Re: PUGET SOUND ENERGY,
Clean Energy Implementation Plan.
Docket UE-210795

Pursuant to the Washington Utilities and Transportation Commission’s (“Commission”) December 28, 2021 Notice of Opportunity to file comments in the above-referenced docket, the Alliance of Western Energy Consumers (“AWEC”) files these comments on Puget Sound Energy’s (“PSE”) Clean Energy Implementation Plan (“CEIP”).

Figure 1: PSE CETA Interim Net Renewable Energy Targets

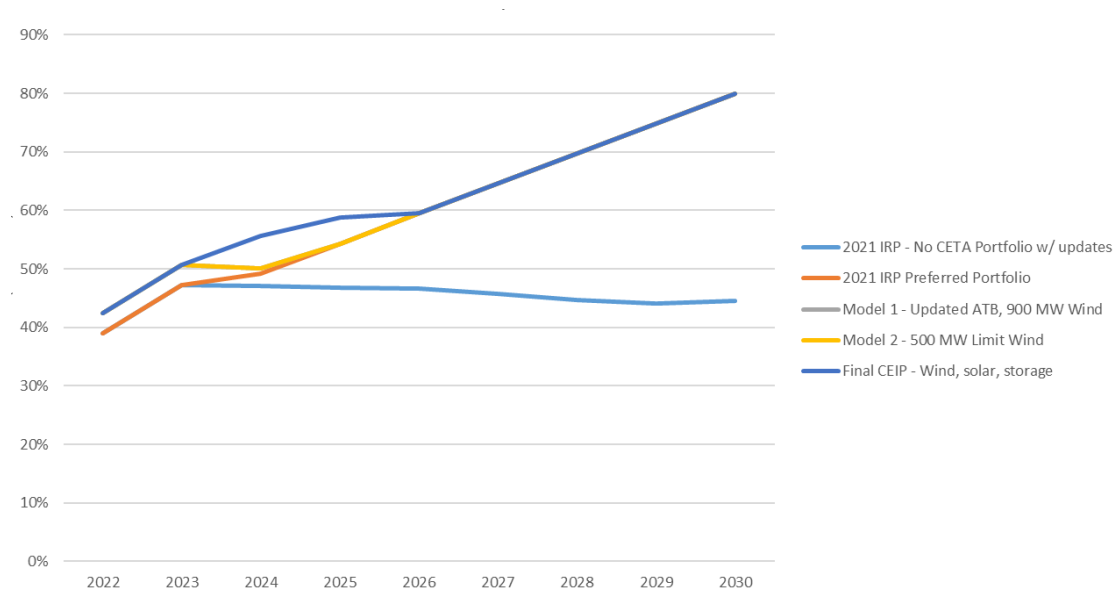
PSE’s 2021 IRP preferred portfolio was developed to accomplish a linear glide path in net renewable energy from 40 percent in 2022 to 80 percent in 2030. The CEIP resource portfolio differs significantly from the 2021 IRP’s least cost, least risk portfolio. The figure below compares the net renewable energy resulting from the 2021 IRP preferred portfolio with several interim models and the Final CEIP.^{2/}

In developing its Final CEIP resource plan, PSE performed additional IRP-type modeling with updated cost parameters. The updated modeling resulted in a least cost portfolio that was very similar to the 2021 IRP portfolio (“Model 1”). PSE arrived at its final CEIP plan by making two costly changes to the least cost portfolio. First, PSE substituted solar generation for wind generation (“Model 2”). Then PSE accelerated the timing of renewable resources identified in Model 2 into earlier years, until CETA’s incremental cost cap became binding (“Final CEIP Model”).

The final CEIP resource plan has more expensive resource types, and resources built earlier, relative to the least cost plan. The plan deviates from the linear glide path assumed in the 2021 IRP and results in a steeper period of resource acquisition through 2024, followed by relatively flat resource acquisition from 2024 to 2026, at which time the IRP and CEIP resource plans converge.

PSE's CEIP costs \$500 million dollars more than a linear glide path. The CEIP proposes resource types and acquisition years that are not legally required, are illogical, and that are not cost effective. AWEC recommends that the interim targets resulting from the 2021 IRP preferred portfolio be adopted.
